Construction of a 6-storey tourist accommodation building, with restaurant/bar, retail, car parking and port cochere

2-7 McLaren Parade, Port Adelaide

040/L074/20

Application No	040/L074/20
Unique ID/KNET ID	5006 and 2020/04578/01
Applicant	CK Property Group C/- Ekistics
Proposal	Construction of a 6-storey tourist accommodation building, with restaurant/bar, retail car parking and port cochere
Subject Land	2-7 McLaren Parade, Port Adelaide
Zone/Policy Area	Regional Centre Zone/ McLaren's Wharf Policy Area 44
Relevant Authority	State Planning Commission
Lodgement Date	25/02/2020
Council	City of Port Adelaide Enfield
Development Plan	Port Adelaide Enfield Council Development Plan (Consolidated 6 February 2018)
Type of Development	Merit
Public Notification	Category 2
Representations	One representation (in support)
Referral Agencies	State Heritage Unit Coast Protection Board Government Architect City of Port Adelaide Enfield
Report Author/s	Hannah Connell – Planning Officer Janaki Benson – Senior Planning Officer
RECOMMENDATION	Development Plan Consent, subject to conditions

McLaren Wharf Port Adelaide - Hotel Development Elevations

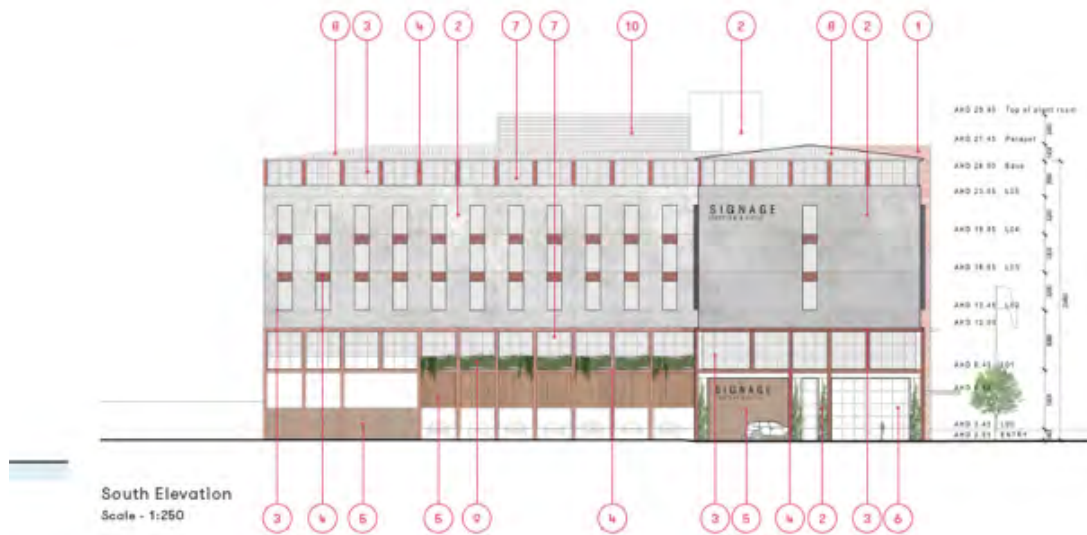
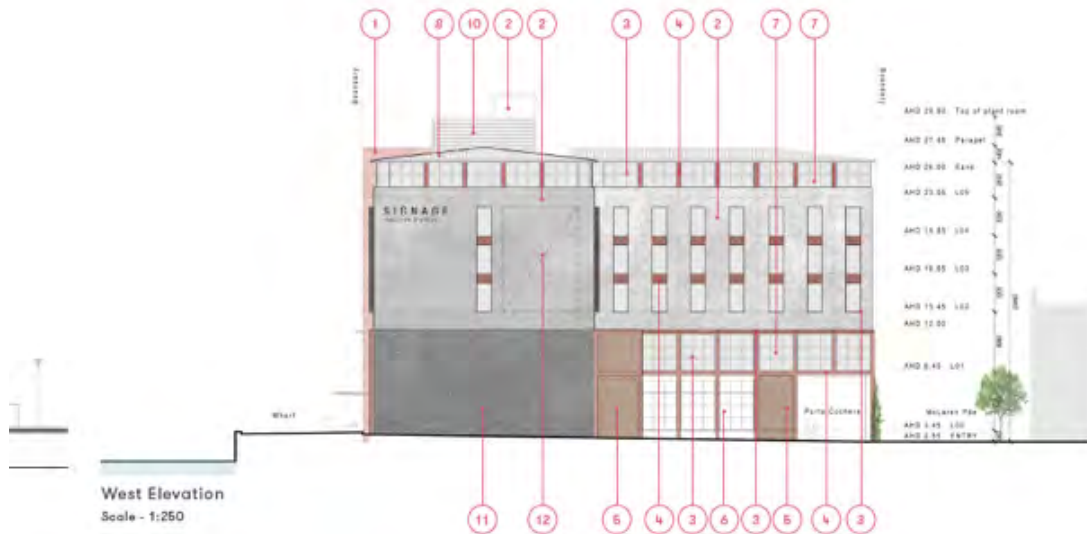
- over height with no design technique to resolve the contextual interface or the greater height that is contemplated in the Development Plan;*
- to have resulting vertically proportioned elements and compositions that fall short of connecting visually with adjacent heritage buildings.*

- *Review of the height, massing, proportions, architectural expression and precast material of the Lipson Plaza wing, including the McLaren Parade elevation, with the view to provide a more convincing transition from the waterfront corner to the State heritage precinct and the predominantly low scale and fine grain character.*

- *In relation to the Lipson Plaza wing and McLaren Parade elevation, I support the design intent for the inclusion of brickwork and additional fenestration to provide further articulation and fine grain character at this interface, however in my view, the revised composition and architectural expression of the Lipson Plaza wing emphasises the visual prominence of the development when viewed from Lipson Street. I remain of the view that further consideration of the height, massing and proportions of the building wing is required to provide a convincing response from the waterfront corner to the predominantly low scale character of the State heritage precinct.*

RE: Council Ref; 040/0445/20 – Hotel at 2-7 McLaren Pde Port Adelaide

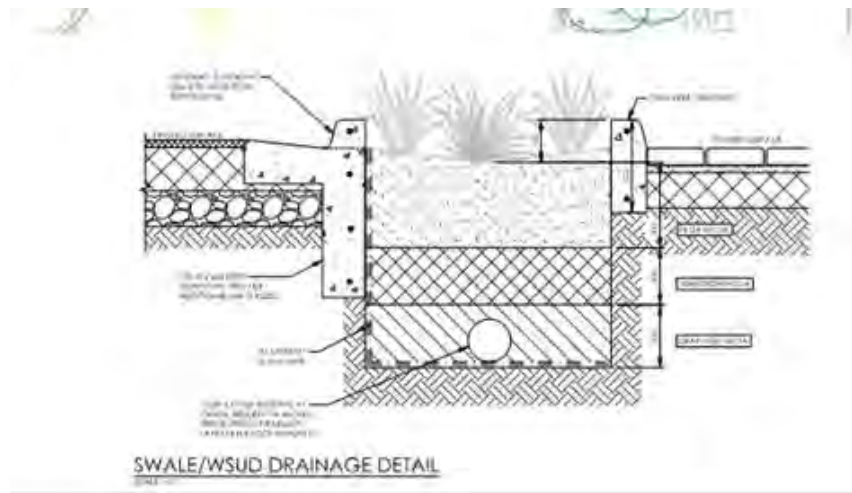
1. The western most entrance to the carpark is to be 'in' only
2. Interface between hotel development and McLaren Parade layout plans needs to be updated to show that McLaren Parade will not be kerbed and instead be a shared space (artists perspective show this but actual civil and floor plans do not)
3. Crossover between eastern most entrance and port cochere eastern entrance to be removed (identified as a red 'x below) – too many crossovers in such a short distance is not desirable form a traffic and pedestrian safety perspective

4. WSUD detail doesn't seem correct – there is no kerbing at the interface of the carpark and also at the interface of the footpath – please modify the detail below to suit the proposed plans

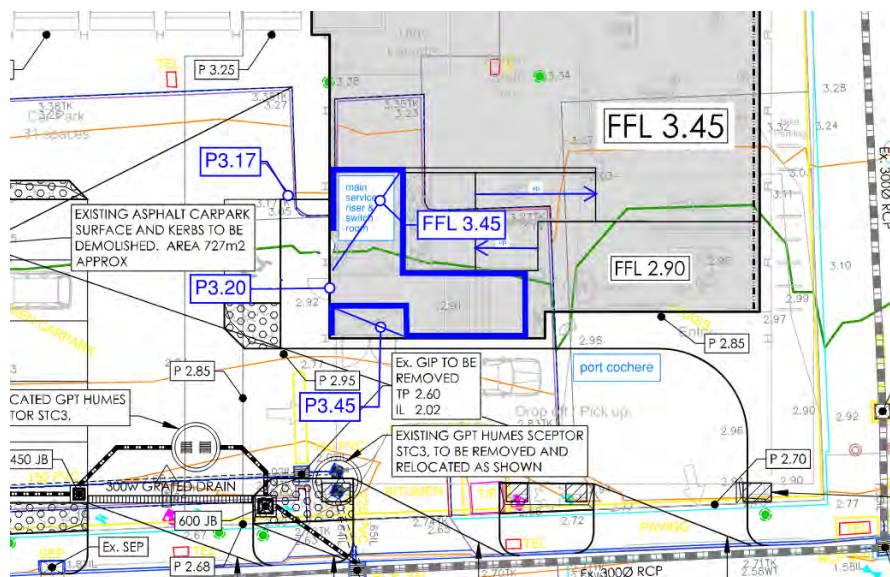
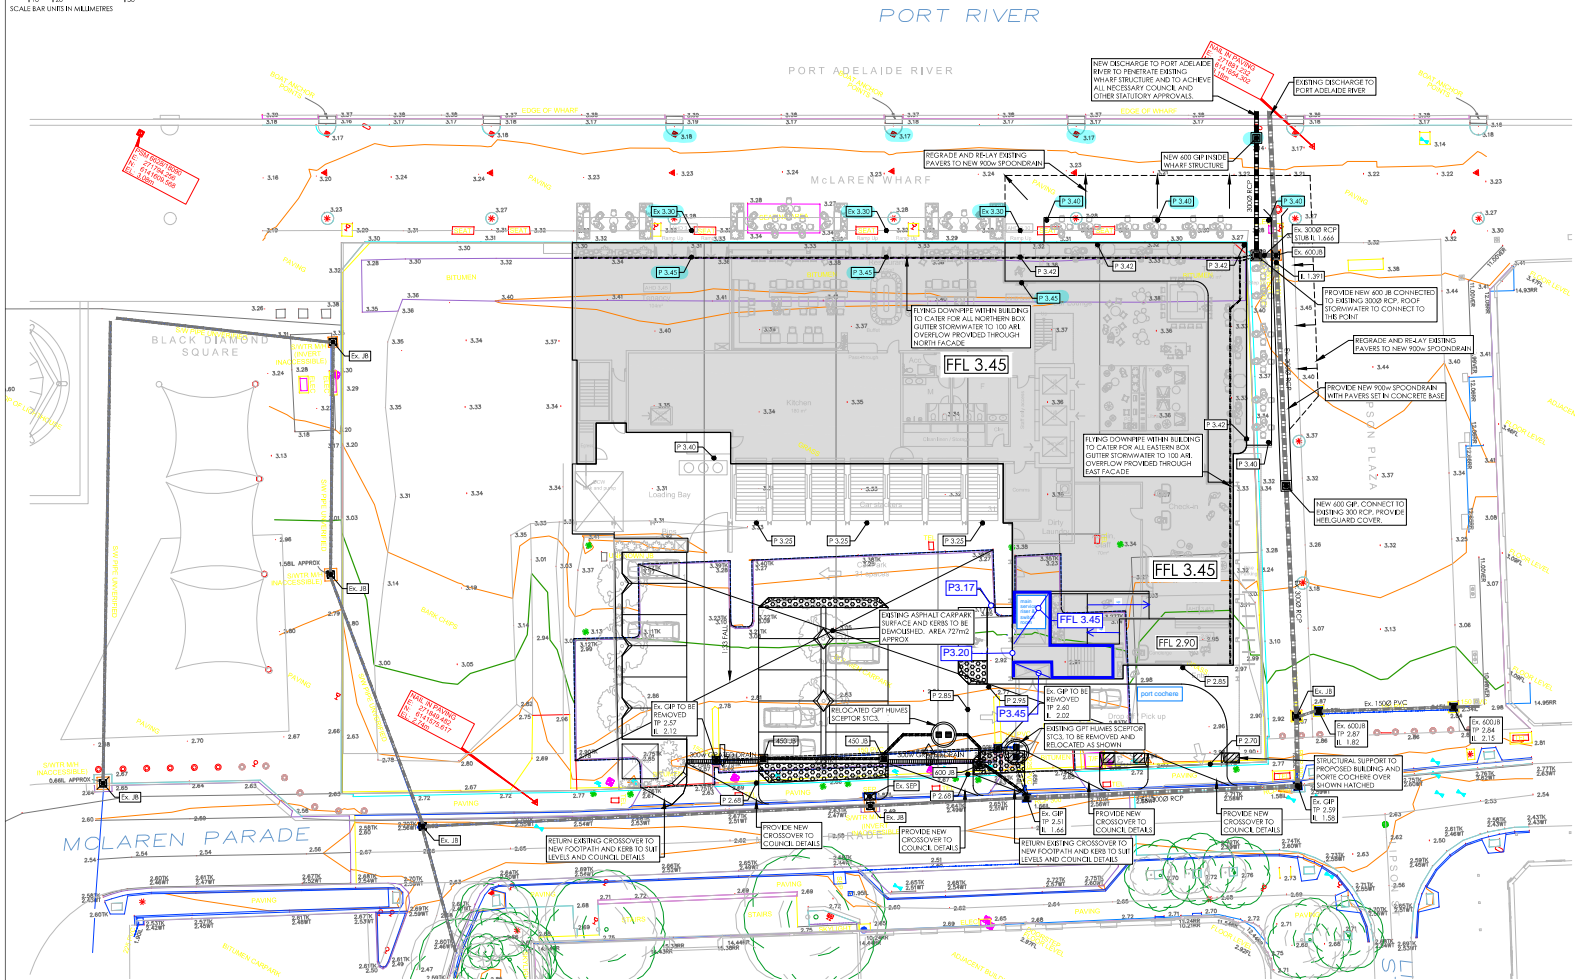
- *Clarification of proposed site levels for the entire development area, including clarification of the proposed level for the Porte Cochere (2.55m or 2.9m AHD)*
- *In the instance that recommended site levels of 3.2m are not proposed:*
 - *Explanation as to why building site levels of 3.2m AHD would not be achieved,*
 - *A detailed description of proposed engineering/design measures to mitigate the effects of any inundation associated with an extreme storm surge event, and assurance that any mechanical or electrical equipment can be made safe from water ingress or raised in accordance with the Board's recommended minimum floor level of 3.45 metres AHD.*

We confirm the proposed FFL for the port cochere is RL 2.90m AHD as identified in the CPR Engineers drawing 190160-C100 Rev A.

We confirm that the pavement access levels within the areas adjacent to the entry of the port cochere are at or just lower than the proposed FFL of the port cochere, RL 2.90m AHD, to service this zone and provide suitable design provisions for access and mobility to the building. Immediately inside the building at the Concierge area, an accessible ramp and associated steps provide access to the main Ground floor level of RL3.45m AHD.

Please refer to the below and attached drawing I90-C100 Rev B for further clarity of design levels and information.
